T.I. no.: 20 - 21 Updated: -	Topic: SC Club Software Version 1.8.3
---	--

Date: 03.12.2020	Priority	Need for action
Affected machines: SC Club	High	As soon as possible
From serial number: -	X Medium	X On next visit to the machine
As of date: immediately	Low	FYI

Mobile Payment

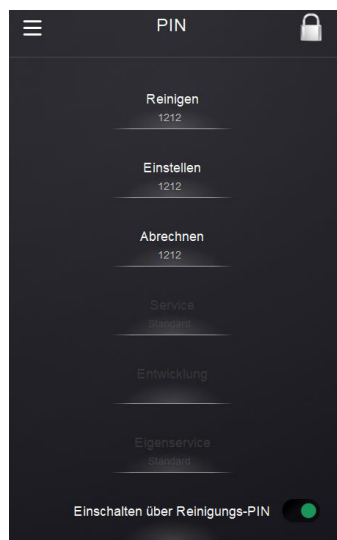
With the new software version, a possibility of selection for e-payment was implemented.

This new feature offers the possibility to use payment services (PaymentServiceProviders) such as WeChat, AliPay or Twint.

Activation under:

System > Maschinen configuration > Accounting > E-Payment

Pressure reduction routine

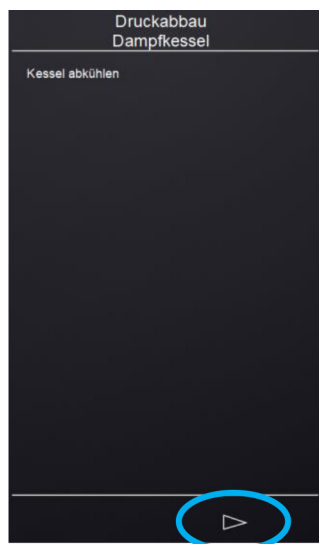
From the field, a case was reported in which after having entered the pressure reduction routine, the boiler heated up until the pressure relief valve triggered.

This could be reproduced by NOT starting "Cool boiler" by means of pressing the arrow key for a longer time after having entered the pressure reduction routine.

This error has been corrected and unwanted heating is avoided.

Switch-off rinsing

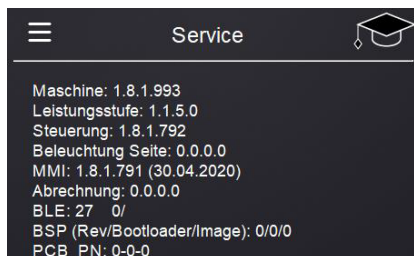
In the previous versions, the "switch-off rinsing" in the system menu could be deactivated by the operator. However, as the switch-off rinsing is an important part of the simplified cleaning concept of the Schaerer Coffee Club, the switch-off rinsing is mandatory upon switching off the machine.

With this software the menu item "Switch-off rinsing" was removed from the system menu and permanently activated in the software.
